UV Reactor Modification Procedure When Replacing 4 kW Power Unit with 8 kW Power Unit

三浦工業株式会社 MIURA CO.,LTD.

This document describes the modification procedure on the UV reactor side when replacing a 4 kW power unit with a 8 kW power unit in the ballast water management system.

Figure 1: Removal of existing 4 kW terminal block (motor side)

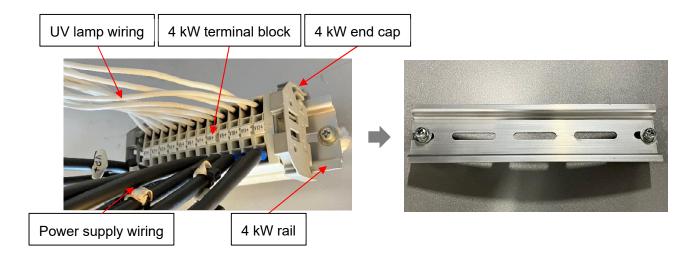
- a) Disconnect the wiring for the UV lamp and power supply from the existing 4 kW terminal block of the UV reactor.
- b) Remove the terminal block and end cap from the 4 kW rail, leaving the rail alone. Discard the removed terminal block and end cap. The 4 kW rail will be reused.

Figure 2: Removal of rail from 8 kW terminal block

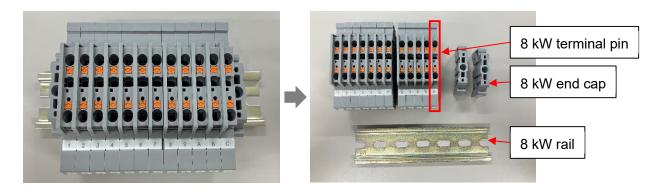
c) Remove the 8 kW rail from the supplied 8 kW terminal block. Please discard the 8 kW rail as it will not be used.

Figure 3: 8 kW terminal block and end caps

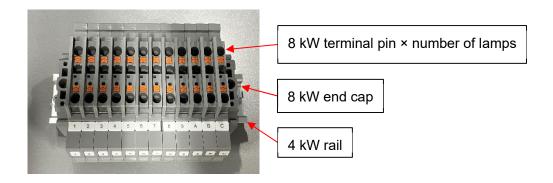
d) Attach the terminal pins (corresponding to the number of UV lamps for the 8 kW terminal block, using pins 1 to 8 for the eight UV lamps specification) and the 8 kW end caps (at both ends) to the 4 kW rail.

Refer to the following conversion table for the correspondence between the existing 4 kW terminal numbers and the new 8 kW terminal numbers.

Figure 4: Disassembly of existing 4 kW UV lamp terminal block (opposite side)

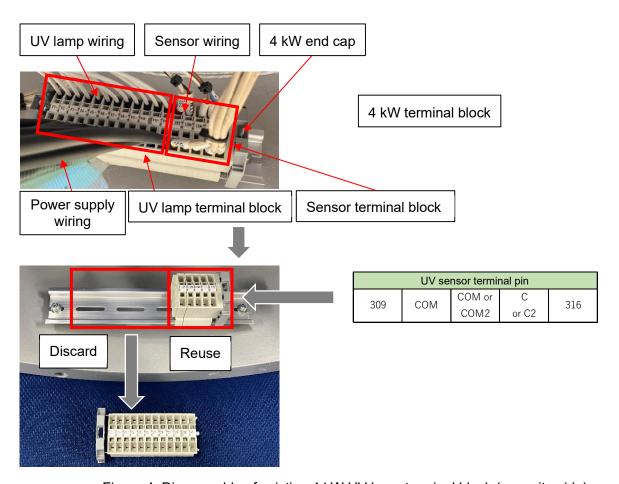
- (4) Change of UV reactor terminal block (opposite side) First time only
 - a) Disconnect the wiring for the UV lamp and power supply from the existing 4 kW terminal block of the UV reactor.
 - b) Remove the UV lamp terminal block and end cap on the UV lamp terminal block side from the 4 kW rail, leaving only the sensor terminal block, end cap on the sensor terminal block, and the rail. Discard the removed UV lamp terminal block and the end cap.
 - *If the workability is poor, remove the sensor wiring.

Figure 6: 8 kW terminal block and end caps

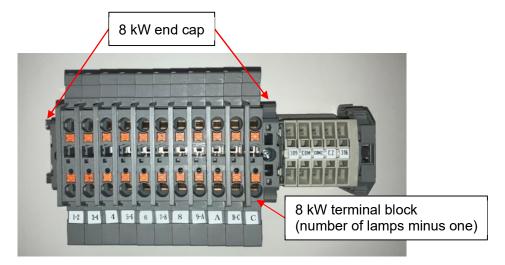
d) Attach the 8 kW terminal pins (number of lamps minus one) and 8 kW end caps (at both ends of the 8 kW terminal block) to the 4 kW rail.

*If the 8 kW terminal block protrudes from the rail, move the sensor terminal pins to the edge.

Attach the terminal pins (number of lamps minus one) in order from left to right.

Example: For eight UV lamps specification, attach the seven pins from left to right, numbered 1-2 through 8. Four pins of 9-A to C are not used.

Figure 7: Wiring connection of UV reactor (motor side)

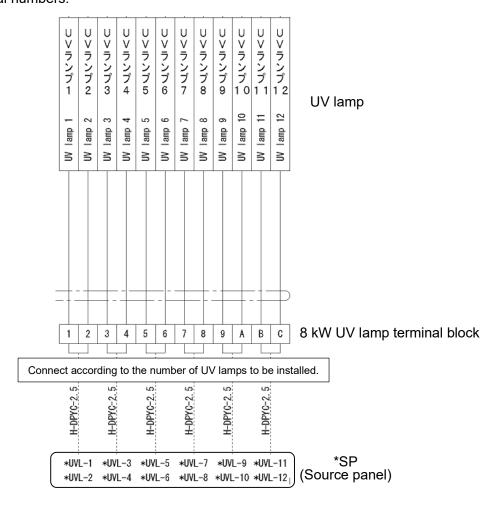
a) Connect the UV lamp wiring to the 8 kW terminal block according to the wiring diagram shown in Figure 7. Connect the wiring so that the UV lamp No. stickers after they have been replaced match the 8 kW terminal numbers.

Figure 8: Series connection of UV lamp wiring (opposite side)

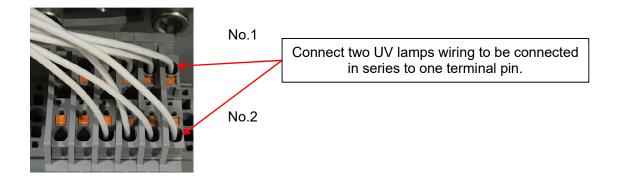
- a) Connect the wiring to the 8 kW terminal block according to the wiring diagram in Appendix B. For the UV lamp numbers, check the UV lamp No. stickers after the replacement. The number of terminals used for the 8 kW UV lamp wiring is reduced from two to one due to the change from the conventional parallel connection to the series connection. Therefore, the single-numbered terminals will not be used for each additional 8 kW power unit replacement.
- b) If the sensor wiring has been disconnected, reconnect it back to its original configuration.
